Access Compliance Report Public Rights-of-Way (Pedestrian Signals)

Main Street: VALENCIA_AVE Cross Street: CARBON_CANYON_RD Location: NE

ADA ID: SGAT210920091427 Signal Type: One Push Button-APS Overall Compliance: No Severity Scores: BTN 1: 0 BTN 2: N/A No BTN: N/A

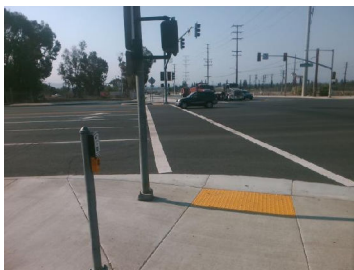
N/A B 1 FWD Approach Obstruction?	N/A	N/A	B 2 FWD Approach Obstruction?	N/A	
N/A B 1 FWD Approach Obstruction Dist (in)	N/A	N/A	B 2 FWD Approach ObstructionDist (in)	N/A	
N/A B 1 PARA Approach?	N/A	N/A	B 2 PARA Approach?	N/A	
N/A B 1 PARA Approach Constrained?	No	N/A	B 2 PARA Approach Constrained?	N/A	
Yes B 1 PARA Approach Reach (in)	0	N/A	B 2 PARA Approach Reach (in)	N/A	
N/A B 1 PARA Approach Width (in)	N/A	N/A	B 2 PARA Approach Width (in)	N/A	
N/A B 1 PARA Approach Obstruction?	No	N/A	B 2 PARA Approach Obstruction?	N/A	
N/A B 1 PARA Approach Obstruction Dist (in)	N/A	N/A	B 2 PARA Approach Obstruction Dist (in)	N/A	
Yes B 1 Clear Floor Space Slope (%)	1.1	N/A	B 2 Clear Floor Space Slope (%)	N/A	
Yes B 1 Clear Floor Space XSlope (%)	1.1	N/A	B 2 Clear Floor Space XSlope (%)	N/A	
N/A B 1 PAR Slope (%)	2.5	N/A	B 2 PAR Slope (%)	N/A	
Yes B 1 Height (in)	42	N/A	B 2 Height (in)	N/A	
Yes B 1 Pressure (#)	5	N/A	B 2 Pressure (#)	N/A

Yes B 1 Closed Fist Operation?	Yes	N/A	B 2 Closed Fist Operation?	N/A	
Yes B 1 Diameter (in)	2.25	N/A	B 2 Diameter (in)	N/A	
N/A B 1 Crossing Direction	S	N/A	B 2 Crossing Direction	N/A	
Yes B 1 DistanceTo XWalk (in)	32	N/A	B 2 DistanceTo XWalk (in)	N/A	
No B 1 DistanceTo Curb (in)	114	N/A	B 2 DistanceTo Curb (in)	N/A	
Parcel Identification Number	308-051-18				
Google Street View Link					
http://www.google.com/maps/@?api=1&map_action=pano&viewpoint=33.92430762,-117.84746522

Possible Solutions: Replace Signal Push Button With APS Button. Remove & Relocate Sign.
